<b>Subject:</b>  COOLANT LEVEL WARNING LIGHT COMES ON	<b>Bulletin No:</b> 01-040/10
	<b>Last Issued:</b> 07/13/2010

- This bulletin supersedes the previous bulletin 01-006/09 issued on 02/10/09. The APPLICABLE MODEL(S)/VINS, REPAIR PROCEDURE, PART(S) and WARRANTY INFORMATION have been revised.
- Changes are noted below in Red beside the change bar.

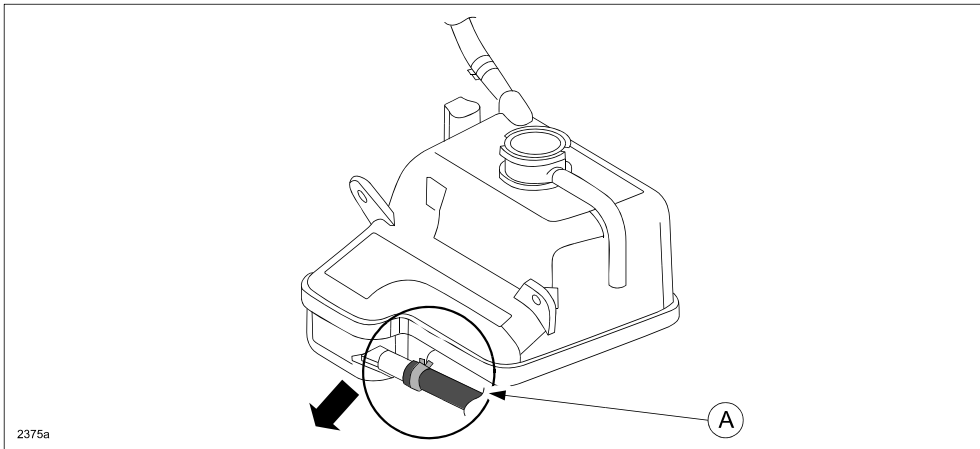
The coolant level sensor float in the coolant reserve tank (A) is deteriorated and absorbs coolant. The float gets heavy, and sinks, causing the the coolant level warning light comes on. As a mass-production change, the design of the float has been modified.

2. Replace the coolant reserve tank (A) with a modified one. Refer to MS3 online service information or Workshop Manual section 01-12 - COOLANT RESERVE TANK REMOVAL/INSTALLATION [13B-MSP].

**NOTE:** When removing the water hose (A) from the reserve tank, remove from the radiator upper tank side first, then remove the reserve tank side. Otherwise the nipple on the radiator upper tank may break.

**Replacement procedure of “tank with sensor”**

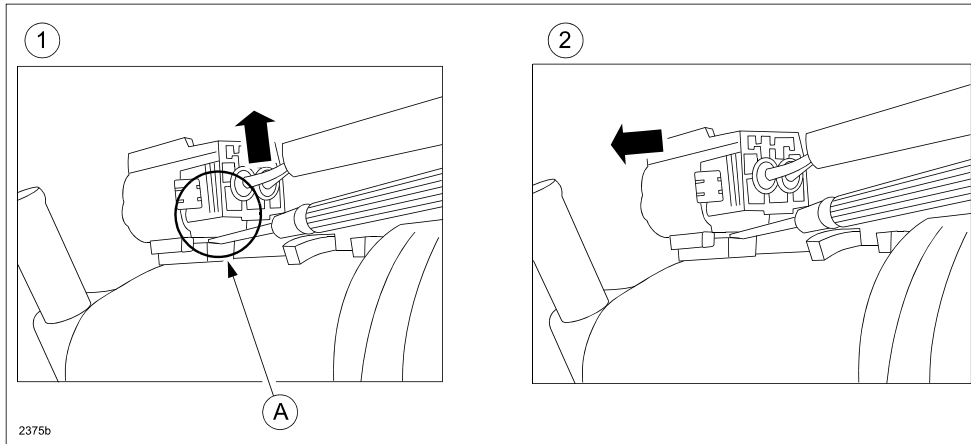
- a. Remove the cooling system cap from the coolant reserve tank; **the cap will be reused.**
- b. Install a new coolant reserve tank (with sensor), then install the coolant system cap.

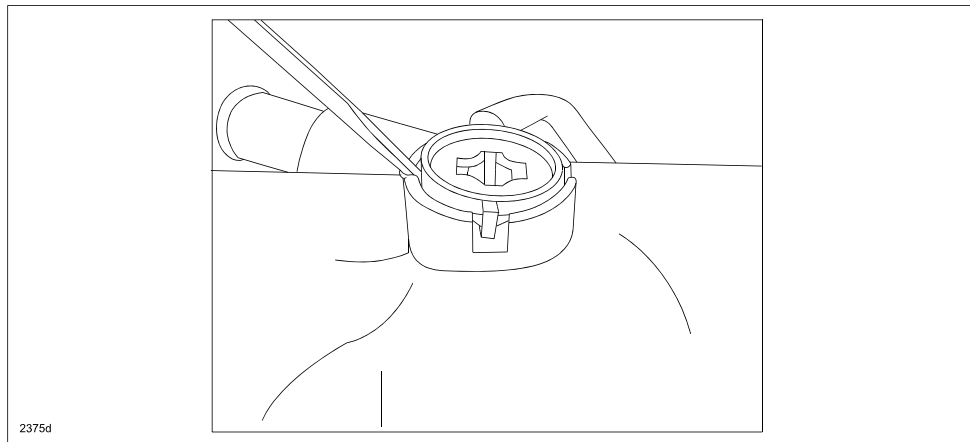
- a. Remove the cooling system cap from the coolant reserve tank; **the cap will be reused.**
- b. Remove the sensor connector from the tank by (1) inserting a flat screwdriver underneath the connector and push up, then (2) slide the connector forward.

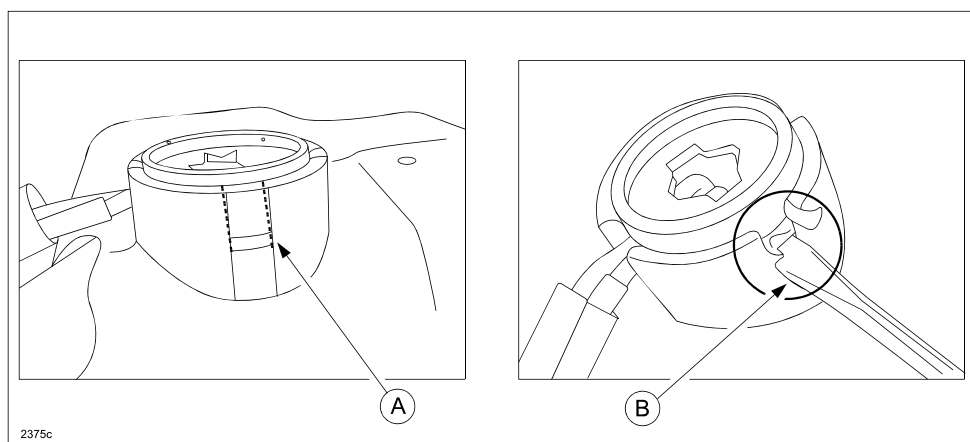
- c. Use a flat screwdriver to pry the sensor loose (on both sides) from the coolant reservoir; the sensor will be reused.

**NOTE:** If the sensor is hard to remove, cut the dotted line (A) as shown (both sides) using cutting pliers, then remove the sensor from the coolant reserve tank using a flat screwdriver (B).
